Design Advisory Board

ZP-25-517; 355 Ethan Allen Parkway (RL, Ward 7) 355 Ethan Allen Parkway, LLC / Norman Benoit

Proposed addition of two residential dwelling units to each existing building for a change from 12 to 18 residential dwelling units total. (Project Manager, Kirk Dressing)

TO: Design Advisory Board
FROM: Kirk Dressing, Associate Planner
DATE: January 13, 2026
RE: ZP-25-517; 355 Ethan Allen Parkway

**2ED FLOOR
 LONG TERM BICYCLE STORAGE
 (2 BIKES)**

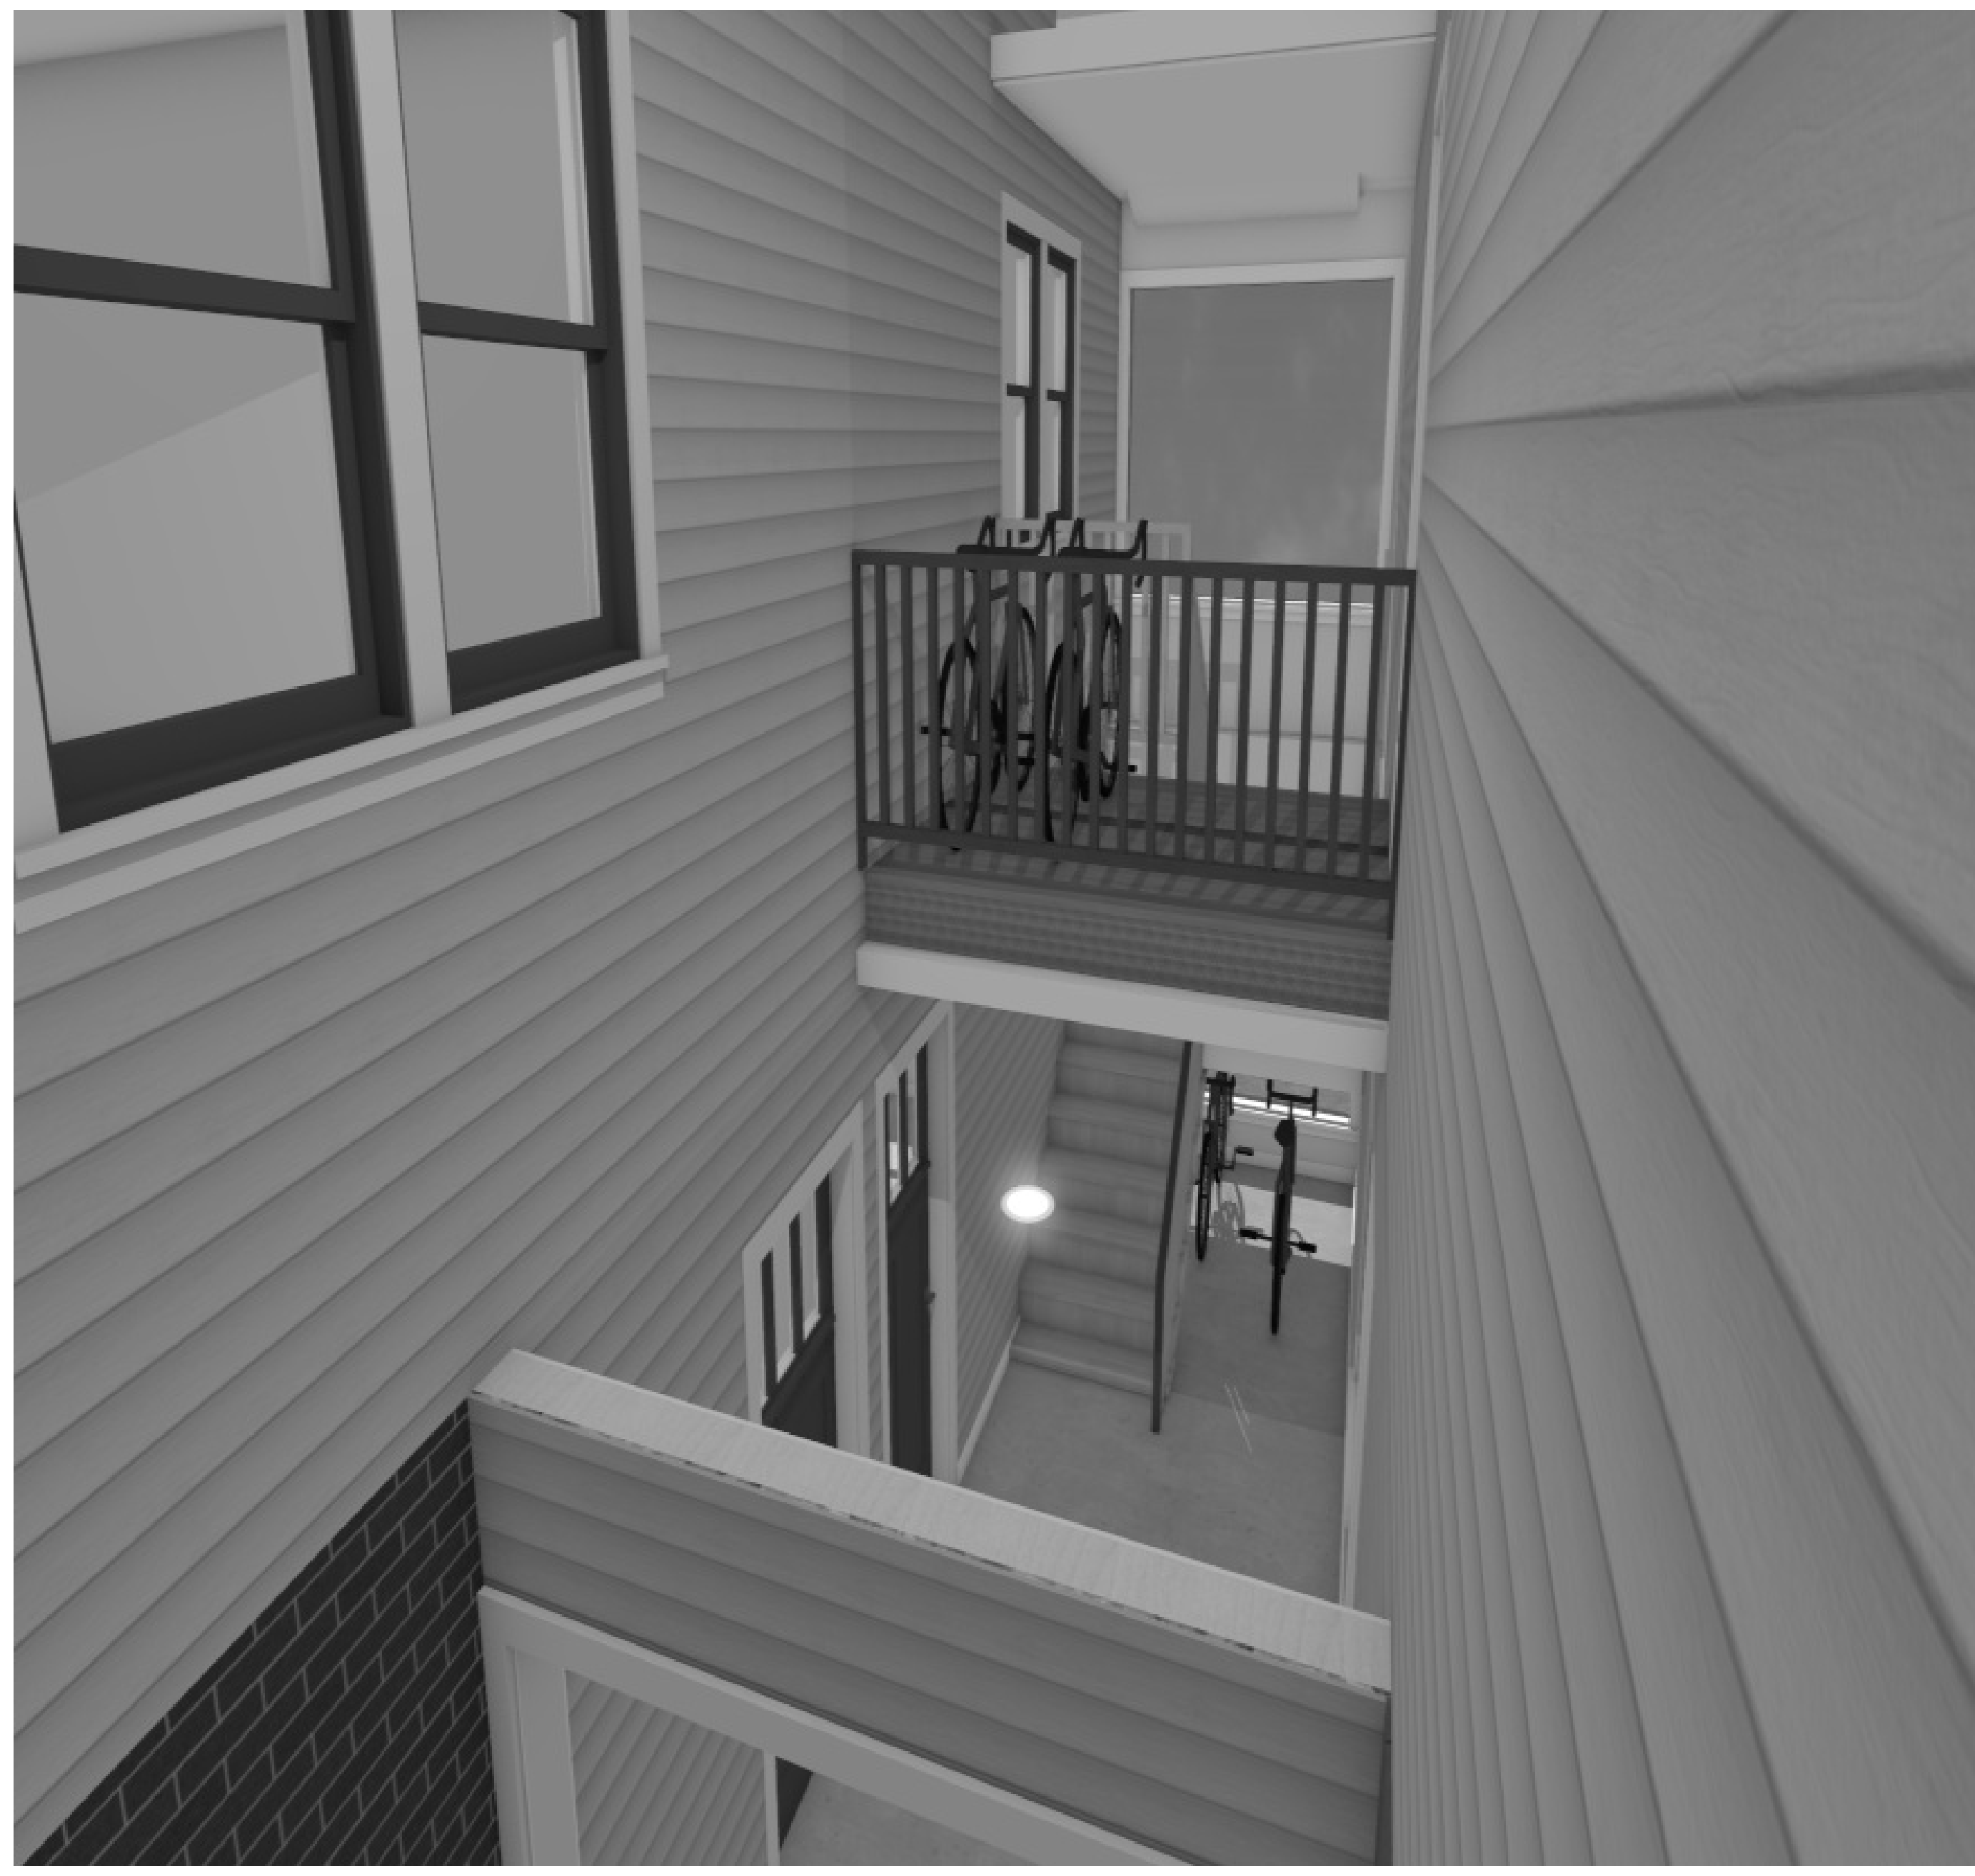
The bicycle parking plan is not clear. There are two different plans for bicycle parking areas, and it is not clear which is being proposed. There are problems with both renderings. Second story bicycle parking is not practical as not everyone is able to regularly carry a bicycle and/or electric bicycle up and down a flight of stairs. The orientation and access to the second level enclosed bicycle parking area is not logical and would likely not function as intended. Maneuvering a bicycle out of the enclosed area would be cumbersome and difficult, and both bicycles would not be able to be removed independent of one another. No changes to vehicular parking or circulation are proposed.

- The bicycle parking plan is not clear, and what has been provided is not practical.
